MEMORANDUM

SUBJECT: Artificial groundwater recharge (AR) application LL-1970 status update

Application AR LL-1970 OWRD Groundwater Review Summary

Figure 1: October static water levels at alluvial aquifer wells in the Walla Walla River Basin, 1940s to present. The map shows well locations relative to AR sites.

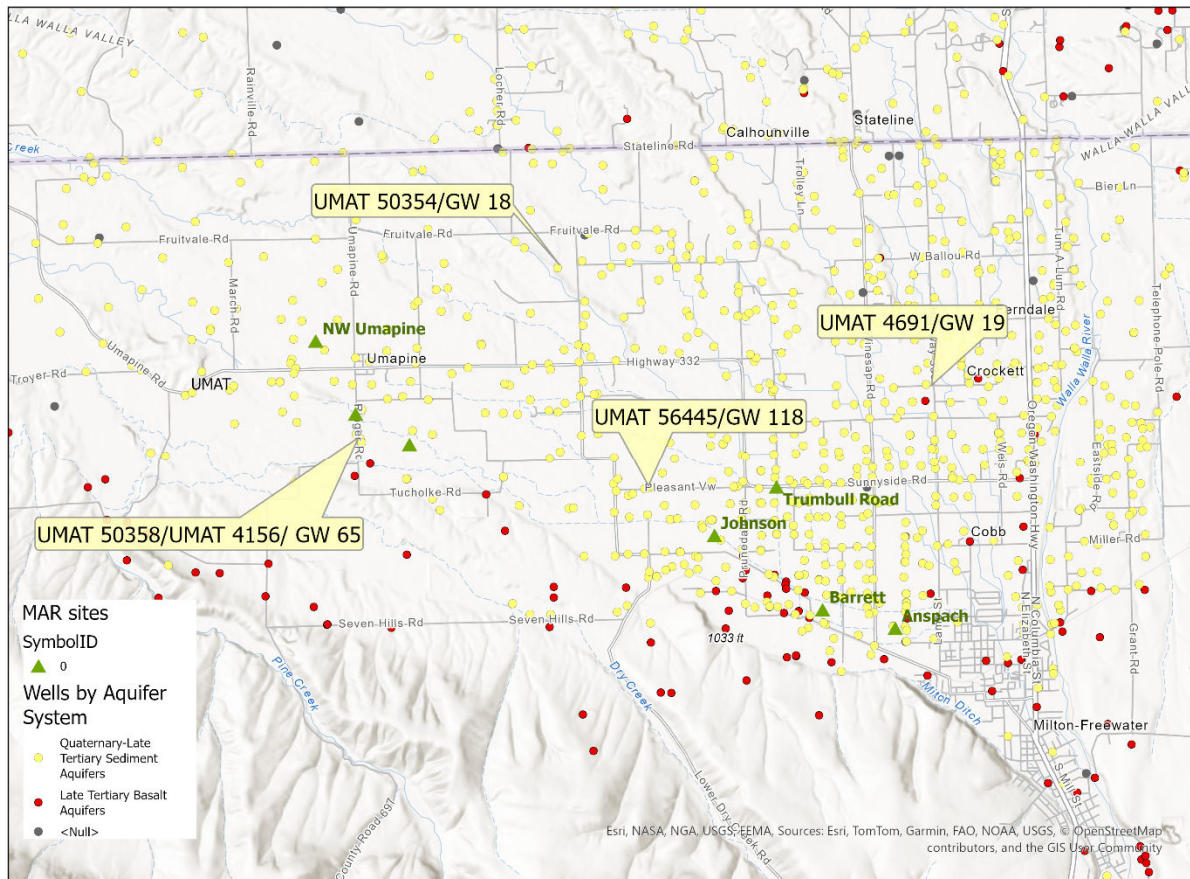
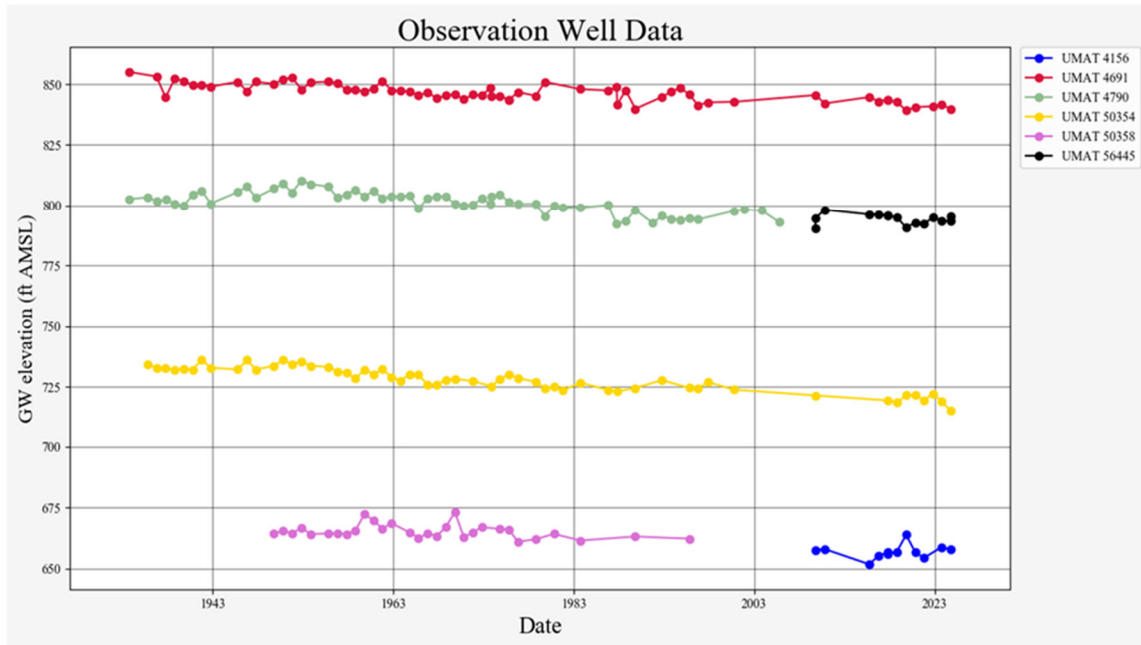
First, OWRD recommends defining aquifer restoration, particularly if the term is used to mean something different from returning static groundwater levels to historic high levels. Secondly, annual reports present groundwater hydrographs one well at a time, in feet below land surface, and include all measurements taken in every season and status: rising, falling, static. It is difficult to quantify trends from these figures, rather they are qualitatively described. OWRD recommends future reports include multiple well hydrographs to examine the timing and

At the long-term observation wells shown in Figure 1, October static groundwater levels have declined from 4 to 19 feet since the 1940s. The AR project has infiltrated approximately 6,000 AF/year for 15 years, for a total of 90,000 acre-feet. This has not returned groundwater to historic high static elevations at these wells. This does not mean the project has no benefits. It does suggest that restoring the aquifer to 1940's groundwater levels is not an attainable near-term goal, given the high transmissivity of the target aquifer and the current project scale. Predictive numerical groundwater modeling by GeoSystems Analysis, Inc. (2016) came to a similar conclusion, estimating that over 20,000 acre-feet infiltrated annually may be required to reach goals.

magnitude of water level changes and how they relate to timing, location and magnitude of AR tests. Consider filtering water level data by season and status.

Figure 2. Groundwater level data from UMAT 4790/UMAT 56445/GW 118, 1940s through the present.

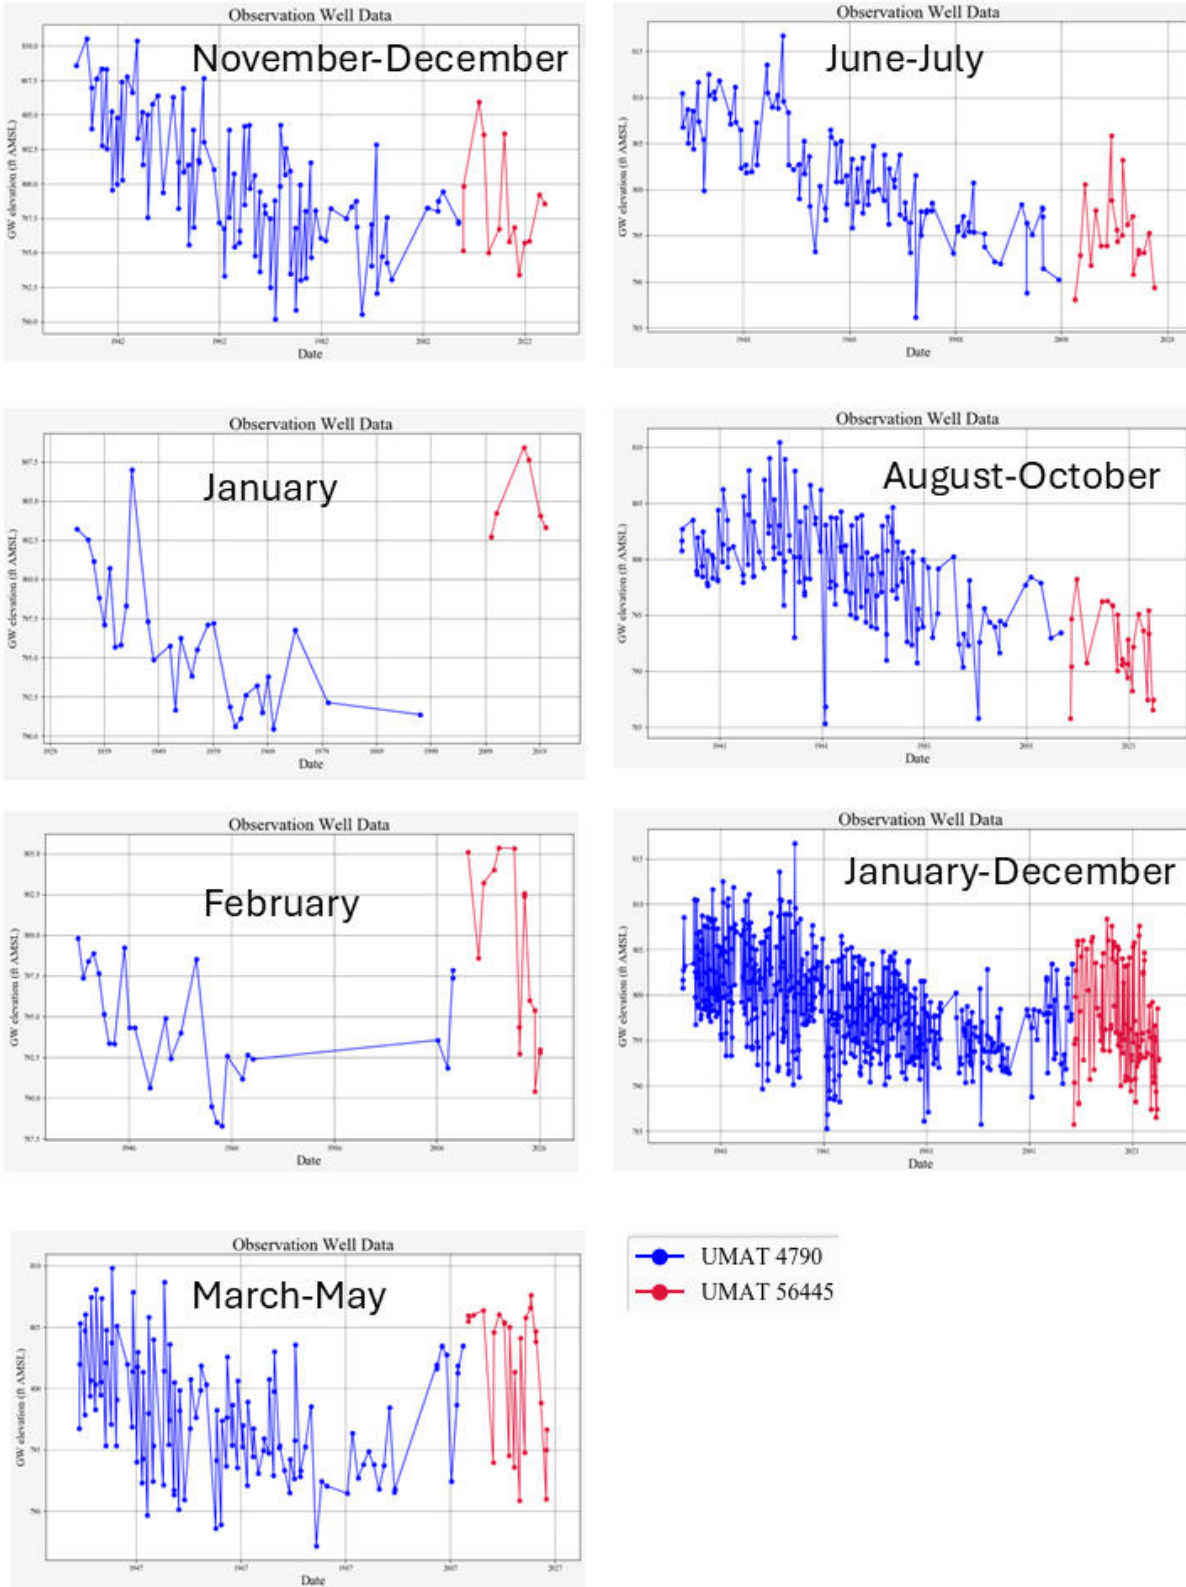
While long-term October static water level data show negligible increases at this well since AR began (Figure 1), other seasonal trends have changed (Figure 2). Annual high groundwater levels are higher than pre-AR levels, and they are time-shifted to earlier in the calendar year than the pre-AR highs. Annual high groundwater levels in the 1940s and 1950s occurred during the months of May and June. Since AR testing began in 2006, annual highs down gradient of the Johnson site occur between December through May. January levels at UMAT 56445 while AR is occurring show a 10-to-18-foot water level increase between 2005 and the present. Annual low groundwater levels remain similar to pre-AR levels. Annual lows occur August through October, with little change between 2005 and the present. In 2025, there was no AR, and November through January water levels at UMAT 56445 remained at pre-2005 levels.

The observation that AR water level increases dissipate within the same calendar year indicates that infiltrated water flows away quickly, to wells, springs and/or along shallow, highly transmissive preferential flow paths within the sedimentary package. Jimenez (2012) conducted a tracer study to track water molecules across the 3,300 feet between the Johnson AR site and UMAT 4790 /UMAT 56445. The average water molecule flow velocity between the Johnson site and UMAT 56445 and the Johnson and Dugger Creek spring vents was 60 meters/day (197 feet/day). Petrides concluded that water infiltrated at the Johnson site flowed primarily along the transmissive upper layers of the alluvial aquifer, while a small fraction infiltrated deeper and flowed more slowly in the same direction.

Project analysis hasn't demonstrated a year-over-year increase in groundwater storage volume, which would manifest as a year-over-year static groundwater level increase outside the recharge season. However, there is a seasonal (winter and spring) increase in groundwater level, and recharged water appears to discharge to the surface or to wells within the same season either to springs or shallow wells. While this doesn't fit a definition of aquifer restoration, it does take pressure off the groundwater system when alluvial aquifer wells pump AR water instead of natural groundwater. These benefits are likely experienced seasonally by a diffuse group of alluvial aquifer and spring branch users.
